Office Action Summary	Application No. 10/789,268	Applicant(s) STAGER, BRADLEY R.	
	Examiner Bena Miller	Art Unit 3725

DETAILED ACTION

Ward

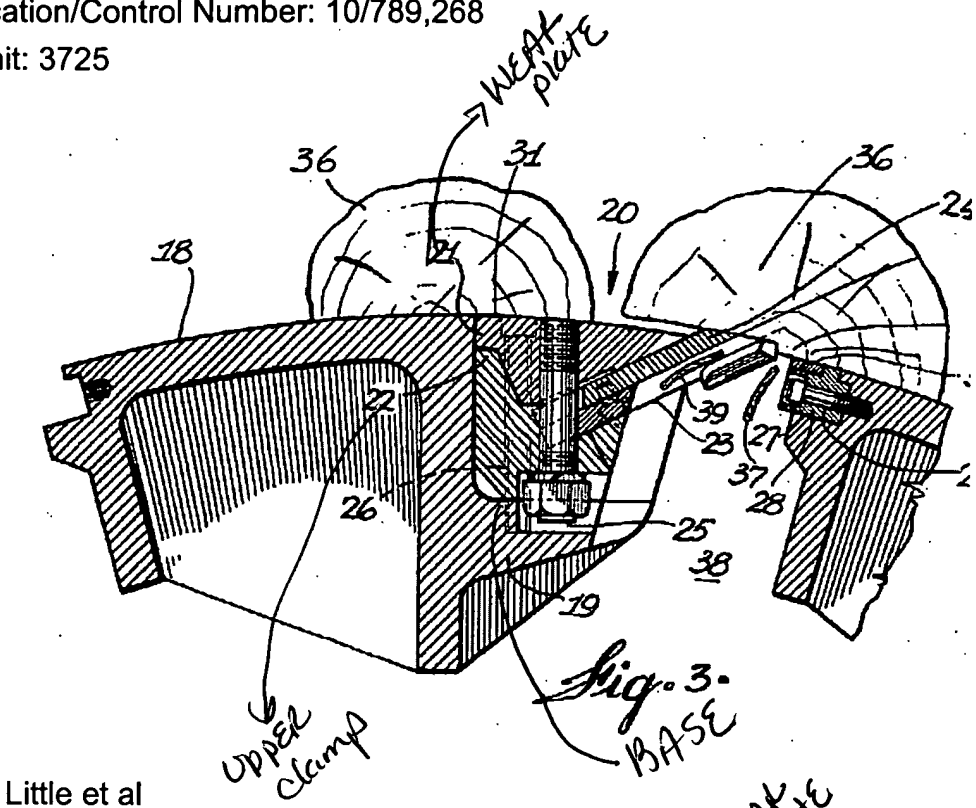
The device of Ward or Little or Nicholson or Hansel reads on the elements of the claimed invention including a knife, a base, a wearshoe, an upper clamping member, the upper clamp member and wearshoe adapted for mounting engagement with the base to provide a gap between the first portion of the upper clamping member that is cantilevered from the base and the apparatus adapted for elastically deflecting the upper clamping member so as to close the gap as seen in the marked up figures below. Little et al further teaches the wearshoe and base including cooperatively interlocking portions wherein portions are adapted to prevent the movement of the base.

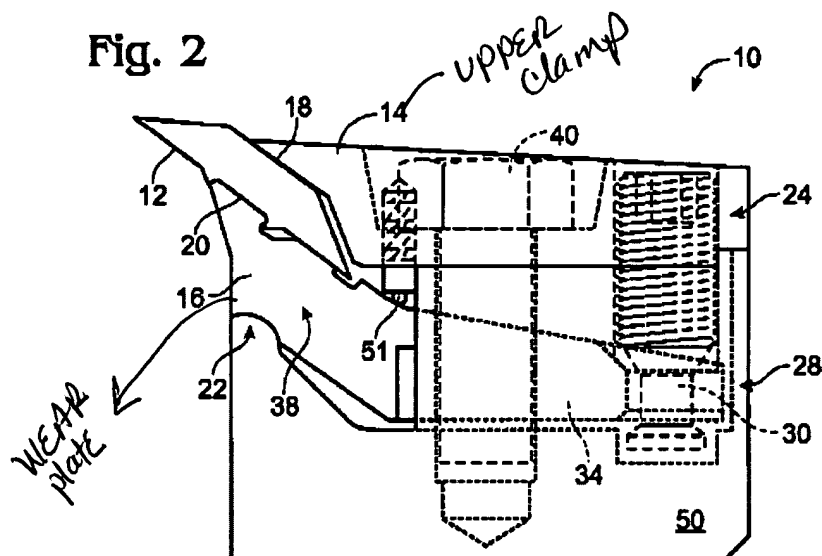
Smartwood teaches in the figures most of the elements of the claimed invention including a base, a upper clamping member and a wearshoe (combination of 34 and 16) as seen in the marked up copy. However, Smartwood fails to teach a ring assembly comprising two end plates. Dean or Loth both teaches wood chipping machine

including a ring assembly having two end plates (fig.3 of either Dean or Loth) for cutting chips. It would have been obvious to one having ordinary skill in the art at the time the invention was made to incorporate a ring assembly as suggested by Dean or Loth in the device of Smartwood for the purpose of cutting chips.
